Re: **Solicitation Addendum # 1 to RFP #25-0325 HBMC FAMILY BIRTHING CENTER RENOVATION Question/Answers; Exhibit A - ICRA Documents; Exhibit B - Flooring Integral Cove Base Revision; Link to HBMC Family Birthing Center Addendum 1 – Design Partners Incorporated.**

Re: **Solicitation Addendum No. 02 to RFP #25-0325 HBMC FAMILY BIRTHING CENTER RENOVATION – DRAWING REVISIONS.**

Re: **Solicitation Addendum No. 04 to RFP #25-0325 HBMC FAMILY BIRTHING CENTER RENOVATION – REVISIONS TO SPECIFICATION-RFI RESPONSES.**

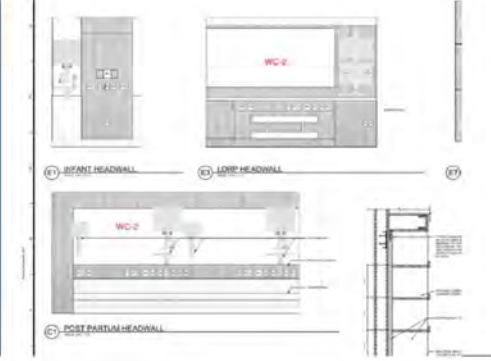
11	Specs call out BCR80 & SCR80. Which model do they actually want	Provide SCR-80
